SANYO: DP50749-02 & DP50719-00

with PANASONIC 50" PLASMA PANEL (MD50H12NBC) SYMPTOM: TV's GREEN POWER LED WILL NOT REMAIN ON

CORRECTION	PRODUCTION CHANGE		IIII	
SERVICE FLASH	ADD INFORMATION		FILE NO.	
Please add this notice	to the Service Manual listed be	low.	REVISION 0	
Category: COLOR TE	ELEVISION	Date: _	OCTOBER / 29 / 2009

Destination: U.S.A. / CANADA REF : **No. SM780163-02**

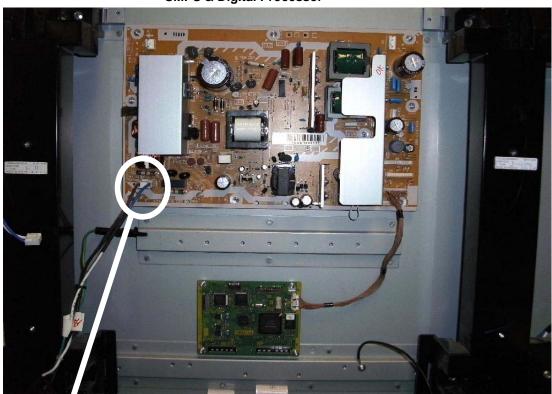
The SMPS can be checked, but <u>all cables & flat ribbons from the SMPS & Digital Processor PCB must be unplugged</u>. The only exception is the cable from D25 (D Bd.) to P25 (SMPS) must be connected. With everything disconnected except this one cable, and when power is applied to the SMPS, the SMPS should turn ON.

No cables attached to SMPS or Digital Bd., except cable from D25 to P25.

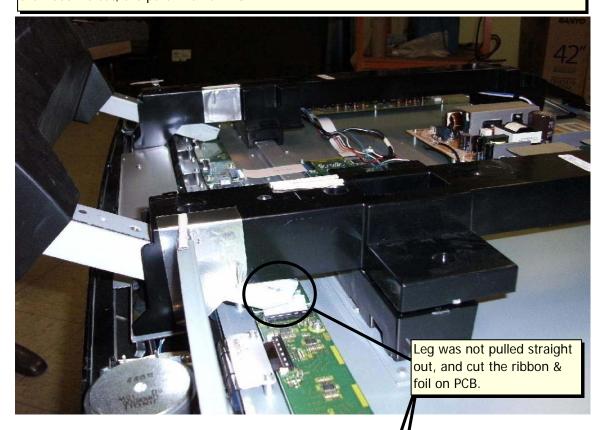
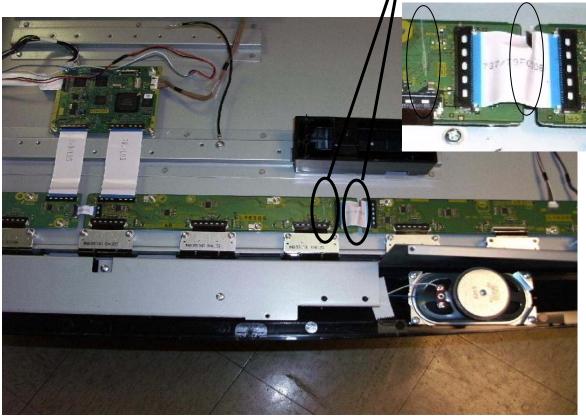
If the Base is removed from the TV, the metal leg can damage the flat ribbon between the C2 & C3 PCBs, if it is not pulled straight out from the TV. It can also cut the foil on the C2 PCB. If the ribbon is cut, the part # is TSXL737.
